3 Detailed description of change

Product Change Notification					New production location of EMC products		
owner	creation date	release date	released by	change order no	rev	page	D10-046-344
segatro	17.06.2020	17.06.2020	accardca	2020126	B	1 of 5

Old product label		New product label

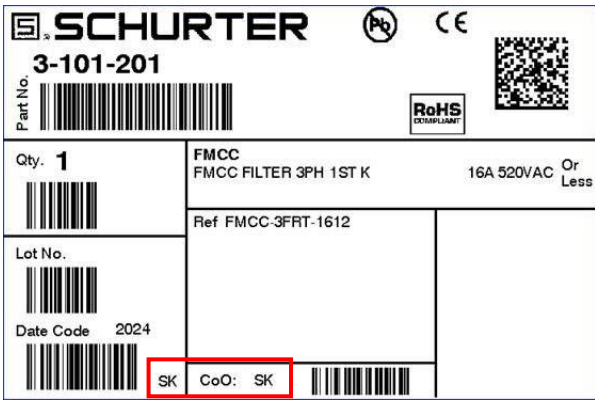
- Change of manufacturing site from Slovakia (SK) to Romania (TO)
- Change country of origin from Slovakia (SK) to Romania (RO)
